MAJOR DEVELOPMENT PLAN AMENDMENT

COVER SHEET
NEW RV STORAGE FOR:
FALCON STORAGE
PART W 1/2 SEC 1, T 13 S, R 65 W, 6th PM
PEYTON, COLORADO

SITE DEVELOPMENT PLAN
**NEW RV STORAGE FOR:
FALCON STORAGE**
PART W 1/2 SEC 1, T 13 S, R 65 W, 6th PM
PEYTON, COLORADO

Site Development Plan_v1 eng.pdf Markup Summary

SDP1.1

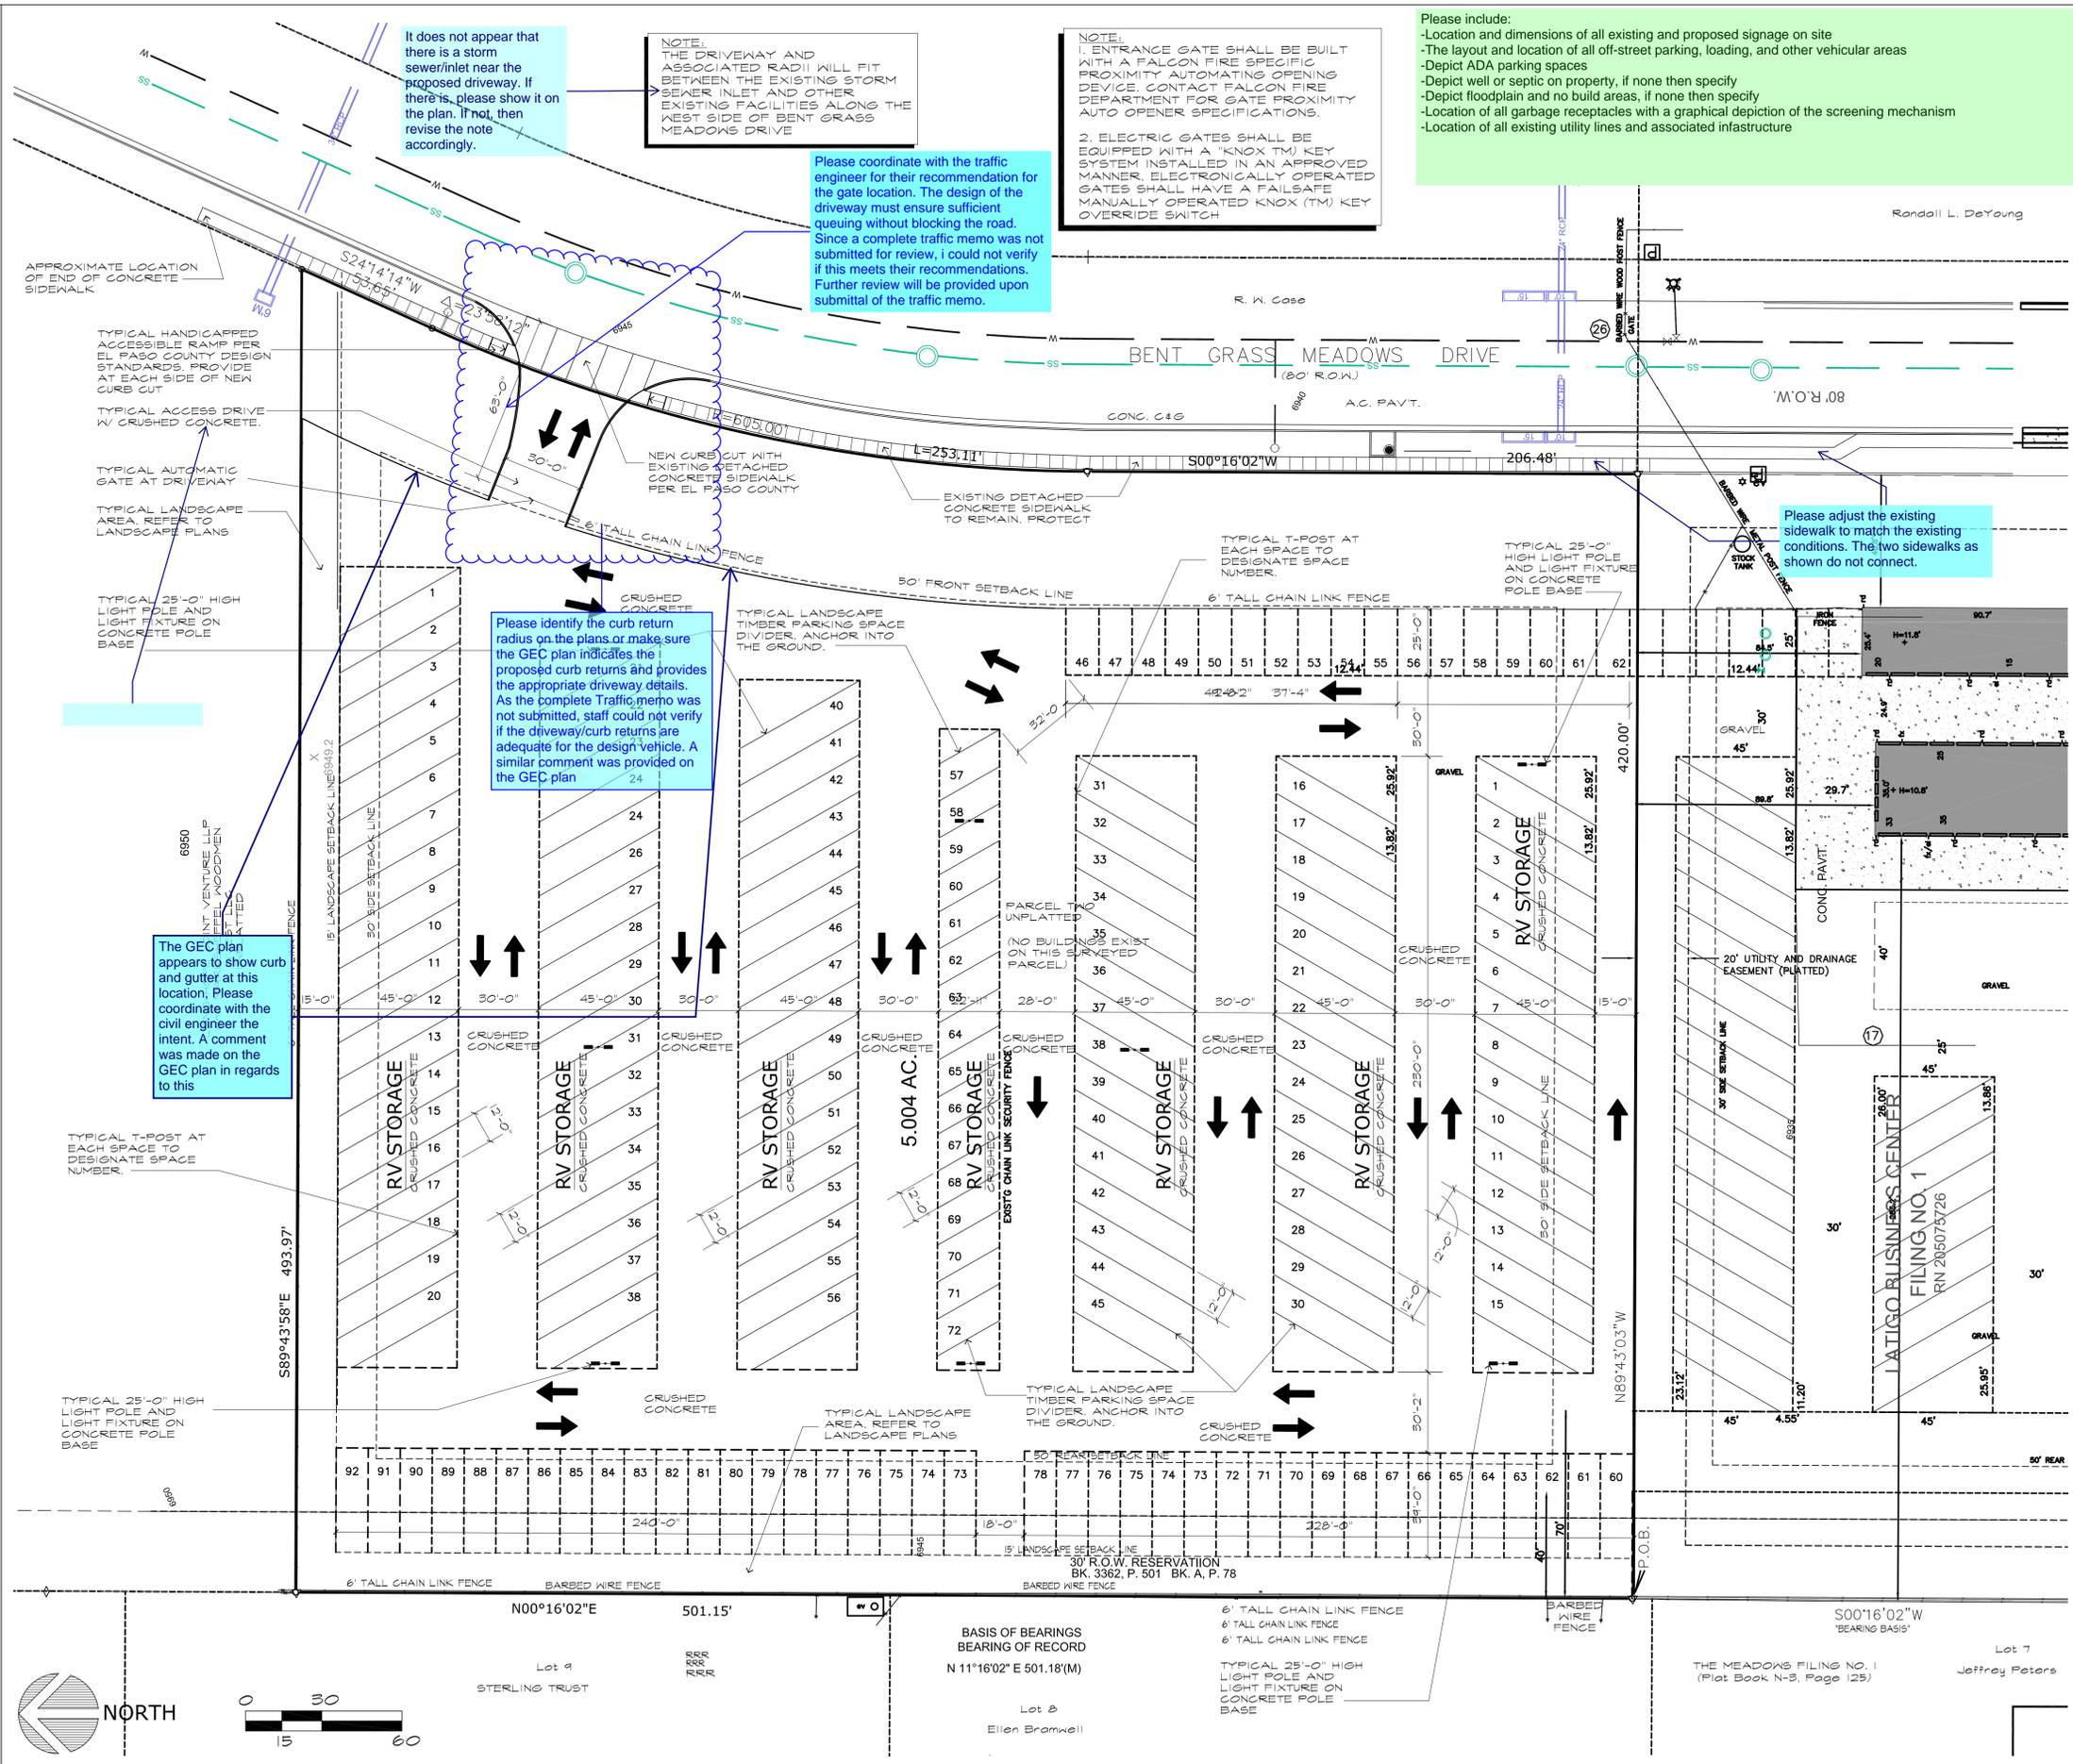
Please identify the setbacks required from Bent Grass Meadows Drive

please update the schedule

Please provide:
-total gross building square footage
-open space, landscaping, and impermeable surface percentage
-parking computations

SHEET
SDP1.2

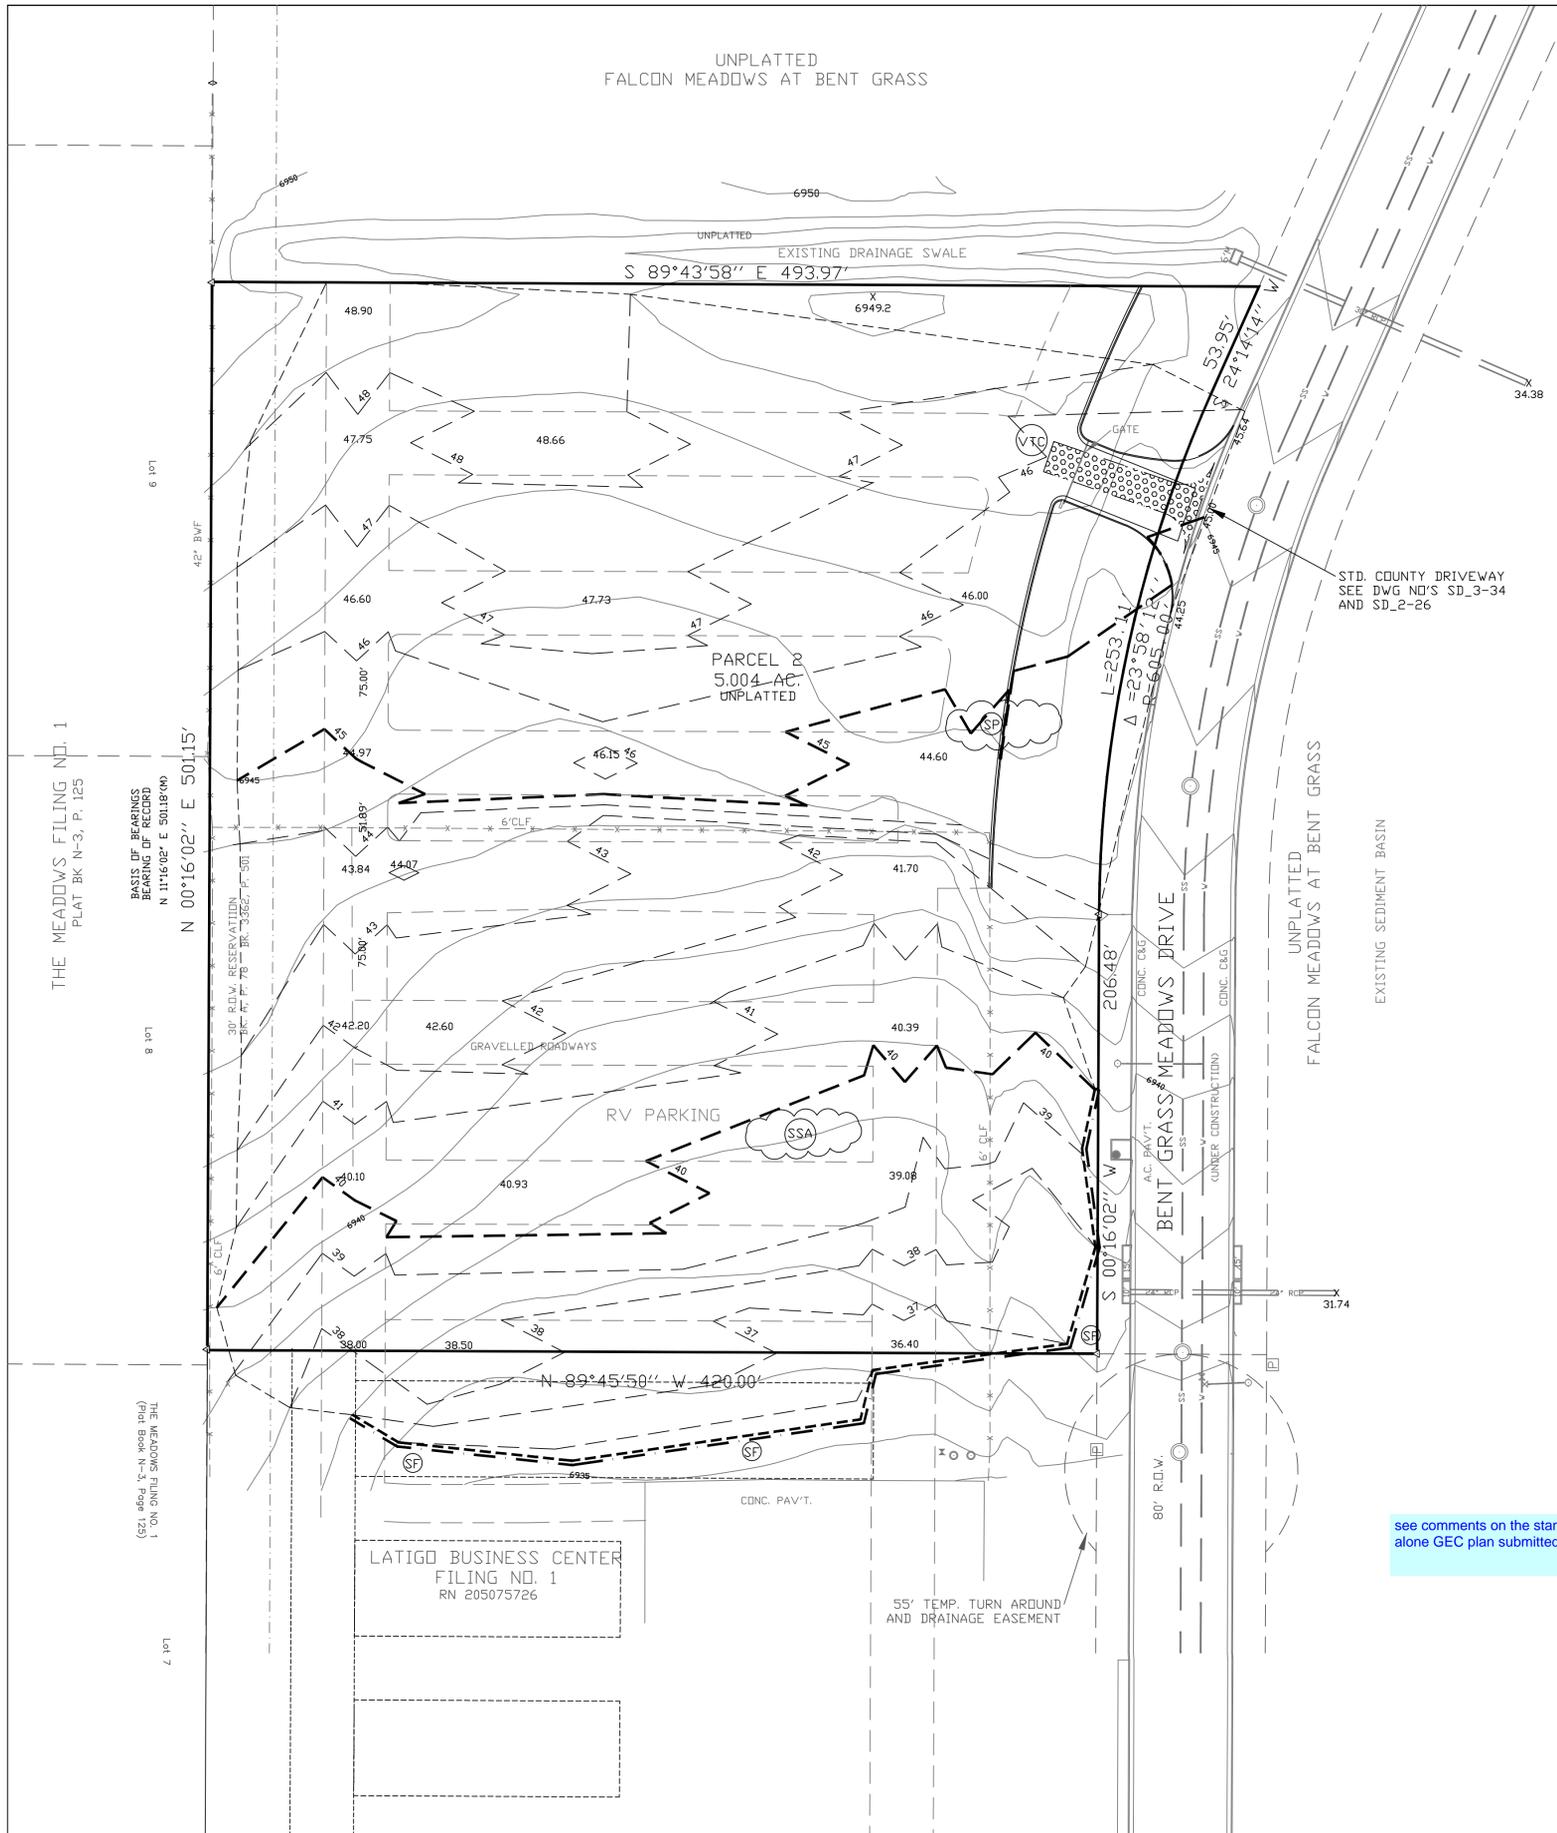
Please include:
-Location and dimensions of all existing and proposed signage on site
-The layout and location of all off-street parking, loading, and other vehicular areas
-Depict ADA parking spaces
-Depict well or septic on property, if none then specify
-Depict floodplain and no build areas, if none then specify
-Location of all garbage receptacles with a graphical depiction of the screening mechanism
-Location of all existing utility lines and associated infrastructure

Please adjust the existing sidewalk to match the existing conditions. The two sidewalks as shown do not connect.

Please coordinate with the traffic engineer for their recommendation for the gate location. The design of the driveway must ensure sufficient queuing without blocking the road. Since a complete traffic memo was not submitted for review, i could not verify if this meets their recommendations. Further review will be provided upon submittal of the traffic memo.

It does not appear that there is a storm sewer/inlet near the proposed driveway. If there is, please show it on the plan. If not, then revise the note accordingly.

Please identify the curb return radius on the plans or make sure the GEC plan indicates the proposed curb returns and provides the appropriate driveway details. As the complete Traffic memo was not submitted, staff could not verify if the driveway/curb returns are adequate for the design vehicle. A similar comment was provided on the GEC plan

The GEC plan appears to show curb and gutter at this location, Please coordinate with the civil engineer the intent. A comment was made on the GEC plan in regards to this

DRAWN BY: D.E. WATTS DATE: 1-29-21 DWG. NO.: 20-5523-03 SURVEYED BY: DEV, ESW, 10-6-20	APPROVED BY:	REVISIONS	PROJECT FALCON STORAGE PARCEL PART W 1/2 SEC. 1, T.13S., R.65W., 6TH P.M. EL PASO COUNTY	SHT. NAME GRADING AND EROSION CONTROL PLAN	SHT. NO. 1 OF 3
	PROJ. NO.

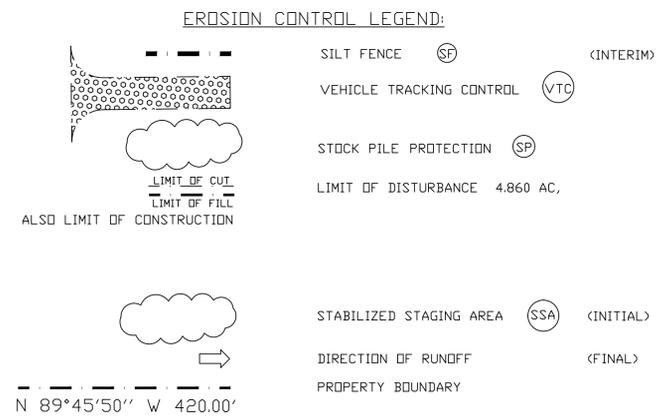
see comments on the stand
alone GEC plan submitted

LANDSCAPE PLAN

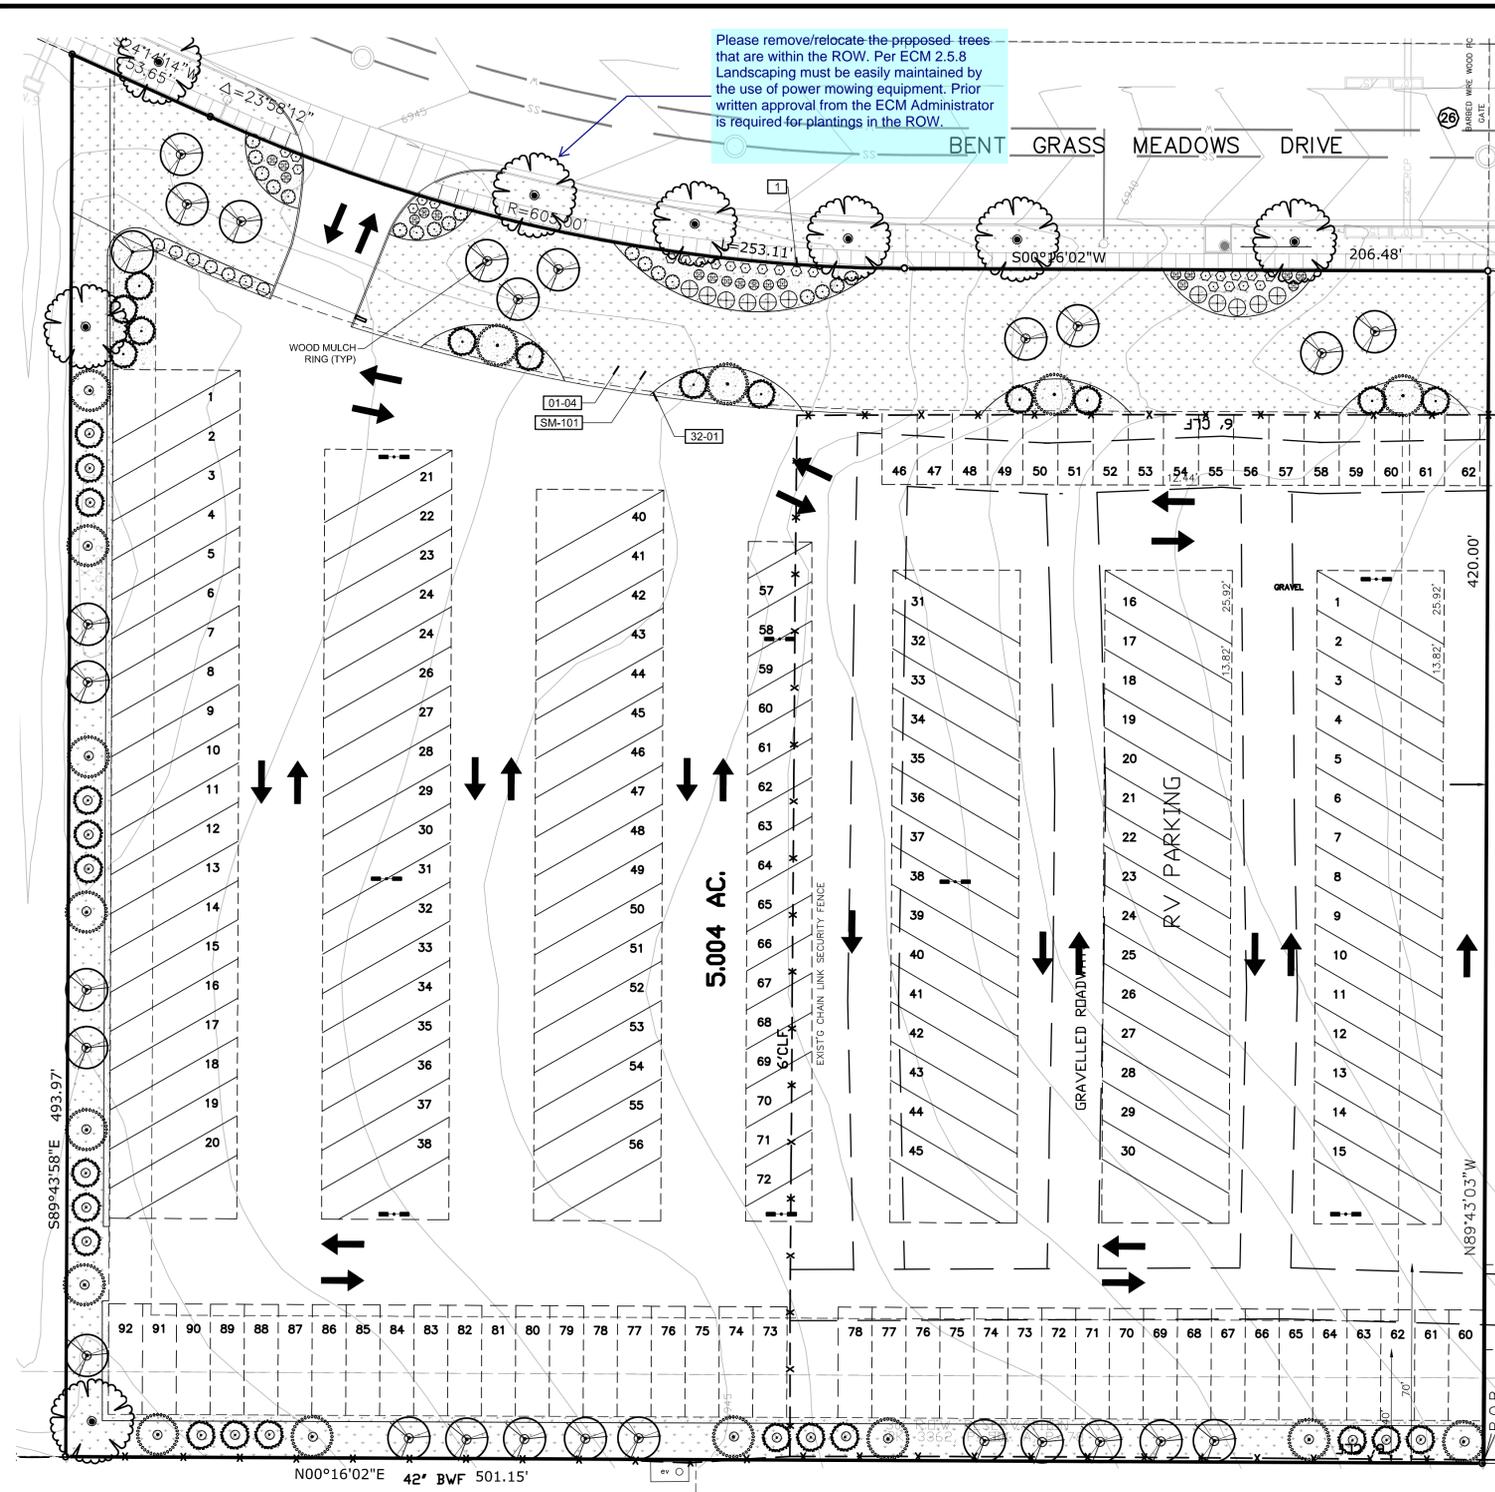
Please remove/relocate the proposed trees that are within the ROW. Per ECM 2.5.8 Landscaping must be easily maintained by the use of power mowing equipment. Prior written approval from the ECM Administrator is required for plantings in the ROW.
